MEMORANDUM

SUBJECT: Terrace in Oak Hill (Formerly called West 71 Office Park)
Planned Unit Development Ordinance Number 20070726-104

Proposed PUD Revision

CASE: C814-2007-0009.01
Terrace at Oak Hill
(formerly West 71 Office Park)

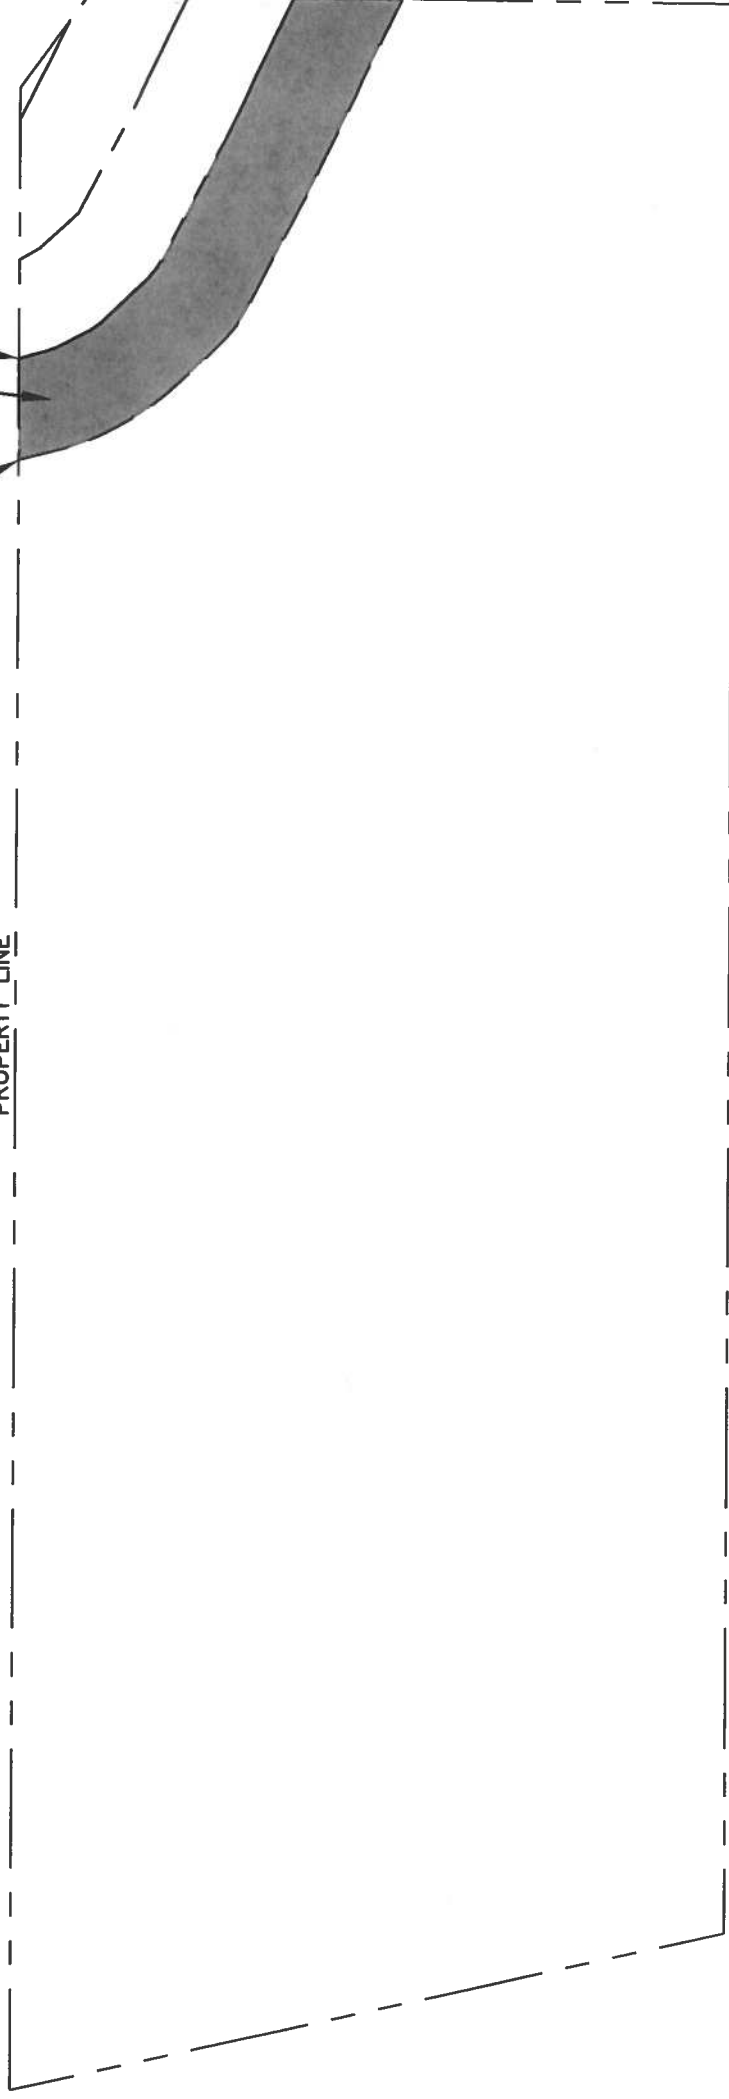
1. The Critical Water Quality Zone located in the northeast corner of the property will be 50 feet wide rather than 100 feet wide; reducing the area of this Critical Water Quality Zone from 0.73 acres to 0.38 acres. This proposed realignment

matches the Critical Water Quality Zone as it is currently shown in the City of Austin GIS.

EXHIBIT D-4

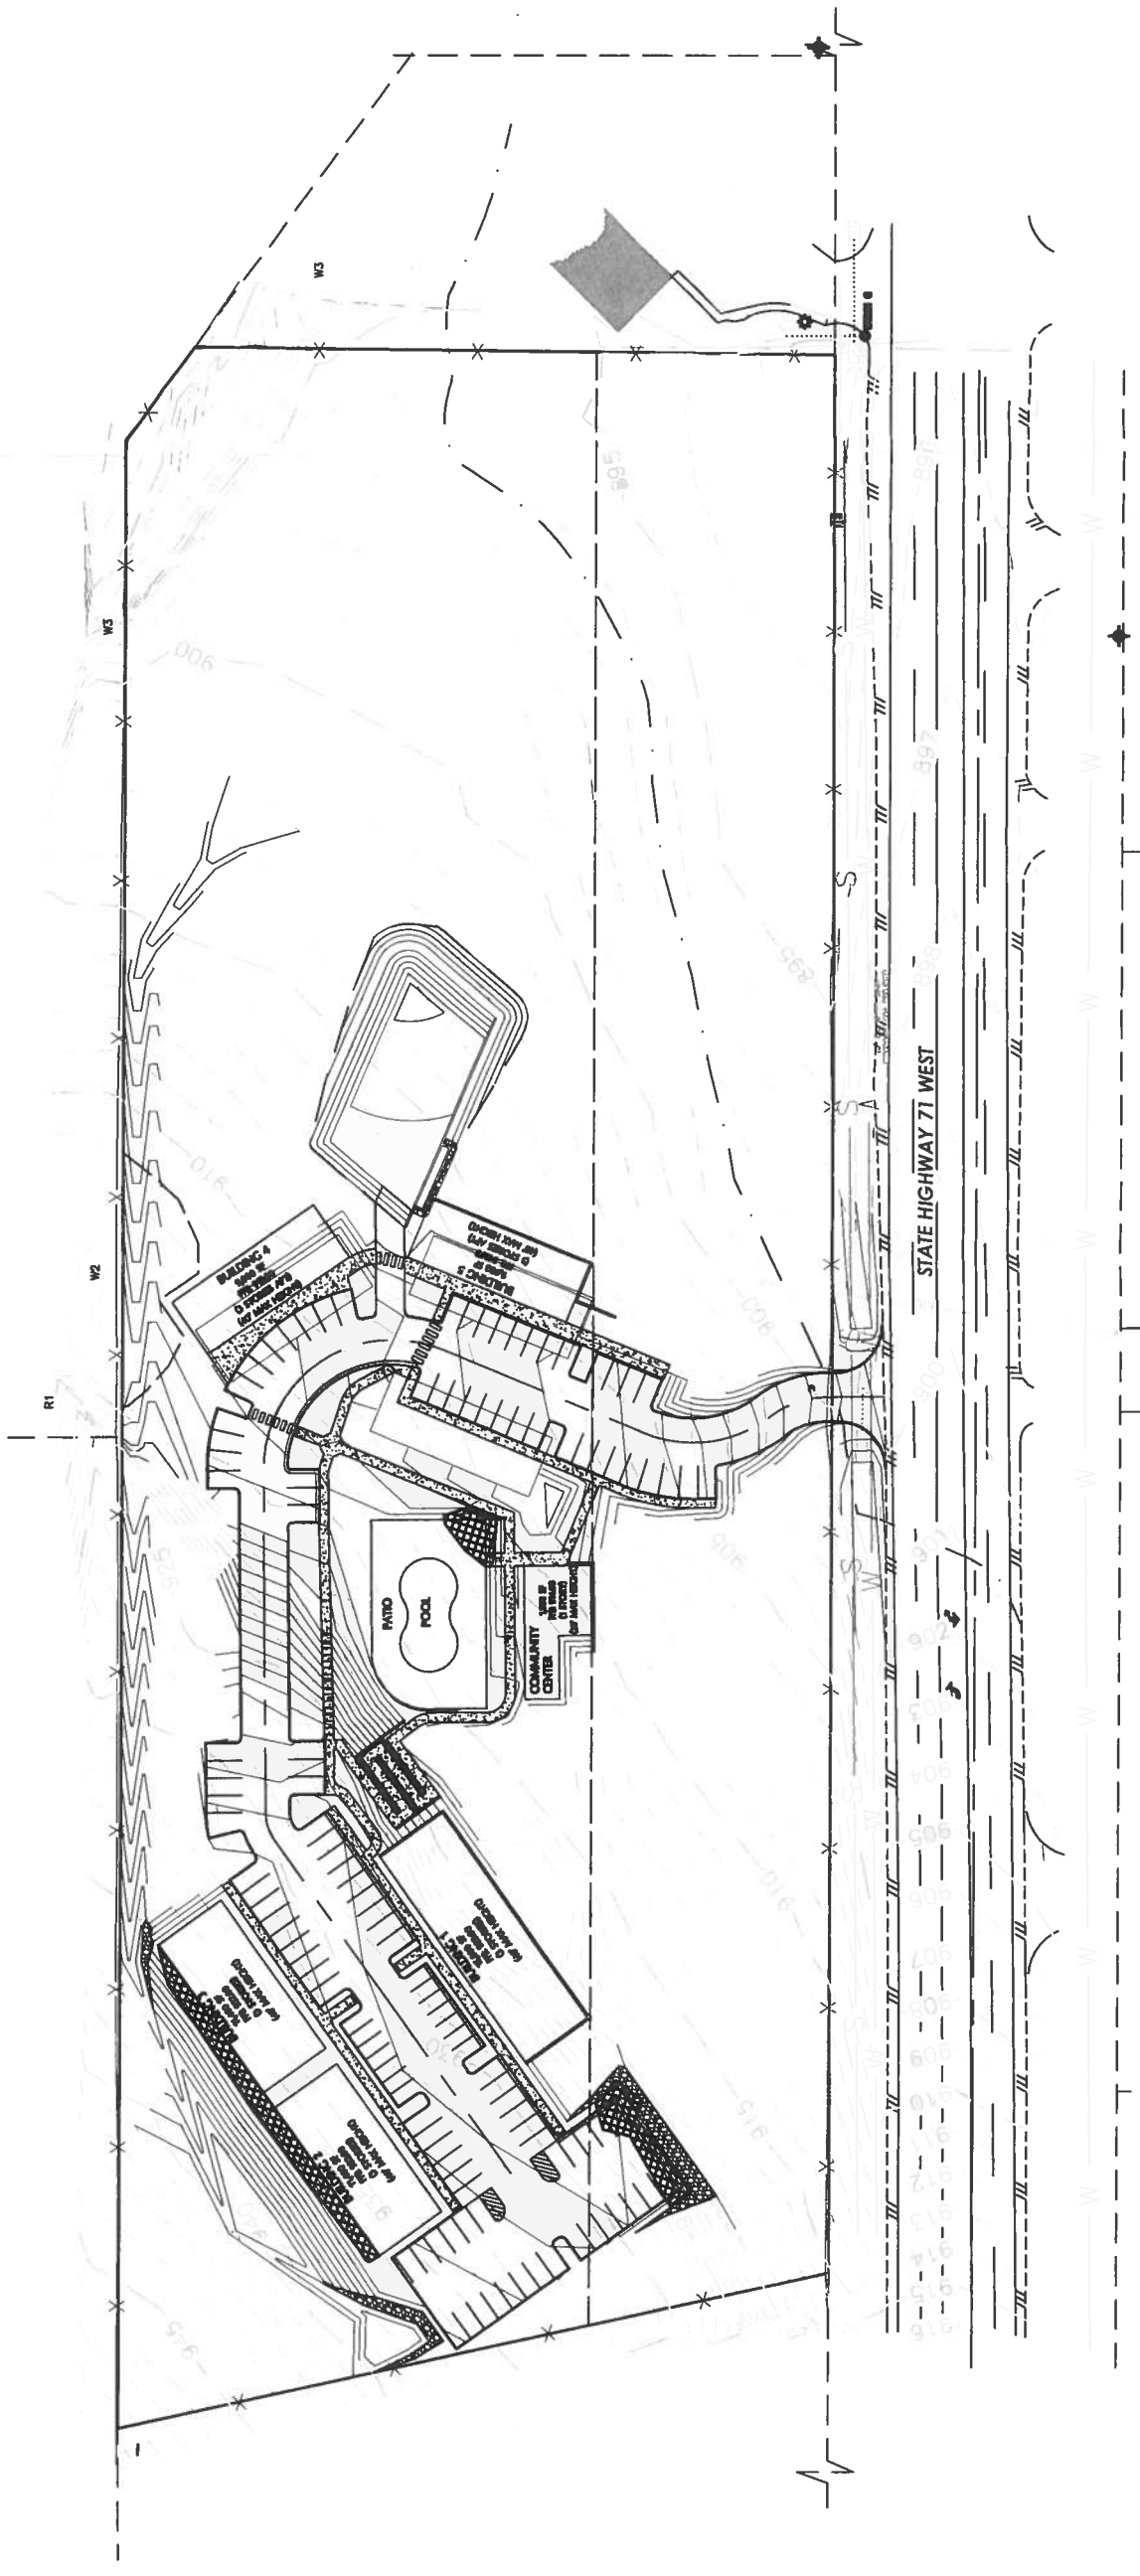
The proposed development requires grading up to 8 feet due to existing topography. In general, grading is limited to 4 feet². The applicant is seeking to amend the approved PUD Ordinance to allow grading up to 8 feet not associated with building foundation construction or water quality / detention pond construction (Exhibit D-4 Cut and Fill).

2. The applicant will limit cut / fill from 4 to 8 feet to an area not to exceed 5,000 square feet (approximately 0.11 acres) and in the vicinity generally depicted in Exhibit D-4 Cut and Fill, provided that:

- a. Areas in which cut / fill in excess of 4 feet are already permitted by the Land Development Code (LDC 25-8-341 and 342) will not be counted in the 5,000 square foot limit;

- b. Areas in which cut / fill in excess of 4 feet are already permitted by the Land Development Code (LDC 25-8-341 and 342) will not be limited to areas generally designated in Exhibit D-4 Cut and Fill;
- c. Administrative variances in accordance with LDC 25-8-42(B)(6) to exceed 4 feet of cut / fill for the construction of water quality control or detention facilities as well as appurtenances for conveyance such as swales, drainage ditches, and diversion berms will not be counted in the 5,000 square foot limit and will not be limited to areas generally designated in Exhibit D-4 Cut and Fill; and
- d. The criteria for evaluating and granting or denying an administrative variance in accordance with LDC 25-8-42(B)(6) will remain unaffected by the revised PUD Ordinance.

Therefore, the Land Use Plan must generally show the areas of cut / fill from 4 to 8 feet as identified in Exhibit D-4 Cut and Fill. In addition, for clarity, at the time of site plan submittal and subsequent site plan review by Staff, Staff recommends that items 2.a. through 2.d. (above) be documented in the revised PUD Ordinance or Land Use Plan.

EXHIBIT D-6

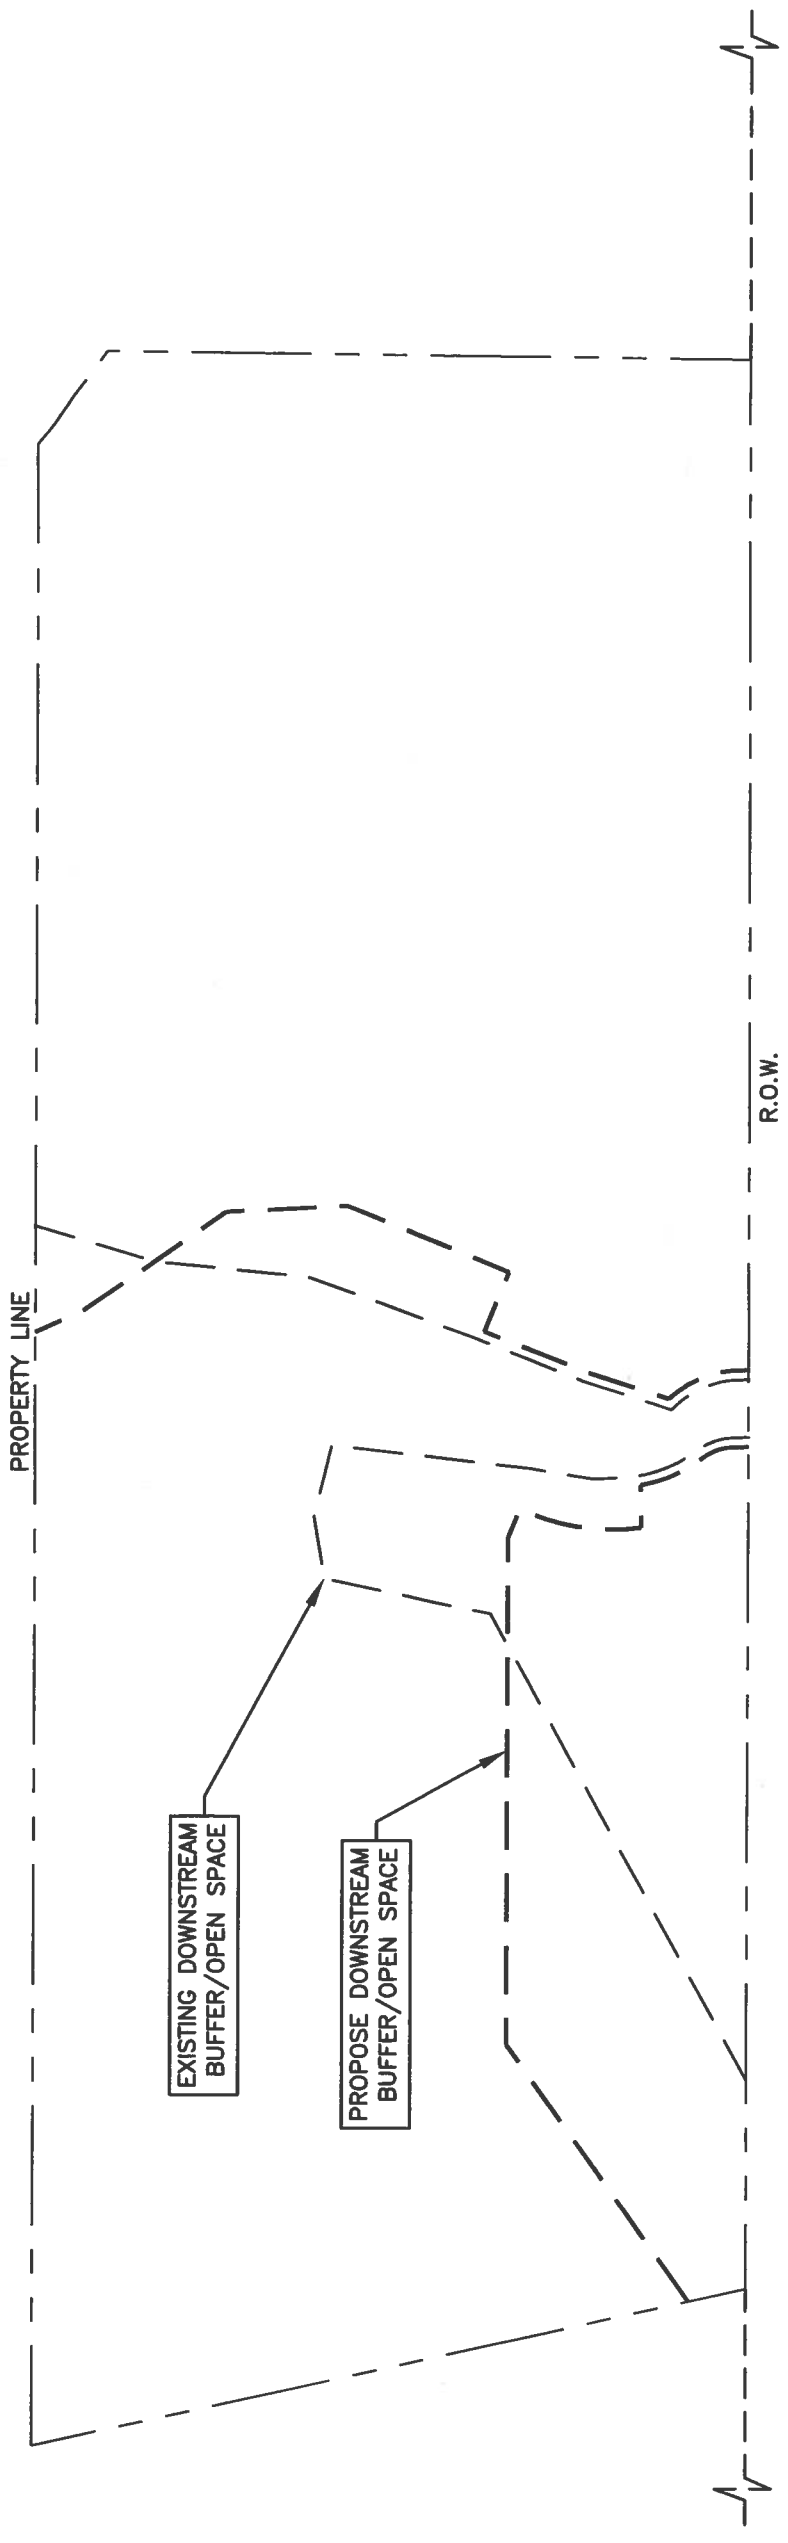
Based on the above proposed revisions to the Critical Water Quality Zone and the Water Quality Transition Zone, the applicant proposes to alter the downstream buffer provided in the PUD Ordinance (Exhibit D-6 Downstream Buffer). The proposed downstream buffer boundary revision will accommodate the proposed swimming pool and patio. The revision will increase the downstream buffer from 3.37 acres to 3.75 acres. Utilities and permeable walking trails will be permitted within the downstream buffer area.

- 4. The revised downstream buffer will increase from approximately 3.37 acres to approximately 3.75 acres.
- 5. The PUD Ordinance or Land Use Plan must specify that no hard surface trails are permitted in the downstream buffer. Trails are permitted in the downstream buffer provided that the trails are constructed of permeable materials installed over non-compacted base.
